# Access Compliance Report

## Public Rights-of-Way

### (Curb Ramps)

Intersection ID: 48956	Main Street: JOSHUA_CAIN_RD	Cross Street: DAVID_JENNINGS_AV	Location:	N
ADA ID: BEDFF8B5BD5B	Ramp Type: Perp	Initial Pass/Fail: Fail	Overall Compliance: No	Severity Score: 12.5
Codes/Mitigation Info/Possible Solution		Field Measurements/Component Compliance

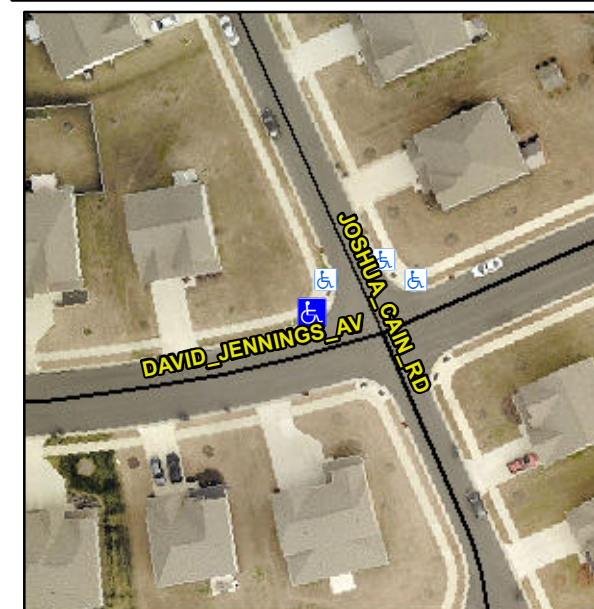
**Not Found, R304.2.2**

Compliance	Description	Data	Compliance	Description	Data
N/A	Ramp Length (in)	63.0	No	Ramp Slope (%)	8.6
Yes	Ramp Width (in)	48.0	Yes	Ramp XSlope (%)	0.2
N/A	Flare Type LT	N/A	N/A	Flare Type RT	N/A
N/A	Flare Slope LT (%)	N/A	N/A	Flare Slope RT (%)	N/A
N/A	Flare Traversable LT?	N/A	N/A	Flare Traversable RT?	N/A
N/A	Landing Length (in)	N/A	N/A	DWS Provided?	N/A
N/A	Landing Width (in)	N/A	N/A	DWS Contrast?	N/A
N/A	Landing Slope (%)	N/A	N/A	DWS Length (in)	N/A
N/A	Landing X Slope (%)	N/A	N/A	DWS Full Width?	N/A
N/A	Landing Curb? (Y/N)	N/A	N/A	DWS Offset (in)	N/A
N/A	Shared Landing?	N/A			
N/A	Gutter Ponding?	N/A	N/A	Gutter Slope (%)	N/A
N/A	Gutter Lip Ht (in)	1.0	N/A	Gutter X Slope (%)	N/A
N/A	Painted X Walk1?	No	N/A	Painted X Walk2?	N/A
	X Walk 1 Direction	To S		X Walk 2 Direction	N/A
N/A	X Walk 1 Width (in)	N/A	N/A	X Walk 2 Width (in)	N/A
	X Walk 1 Slope (%)	5.2		X Walk 2 Slope (%)	N/A
	X Walk 1 X Slope (%)	2.6		X Walk 2 X Slope (%)	N/A

**Remove & Replace Entire Ramp.**
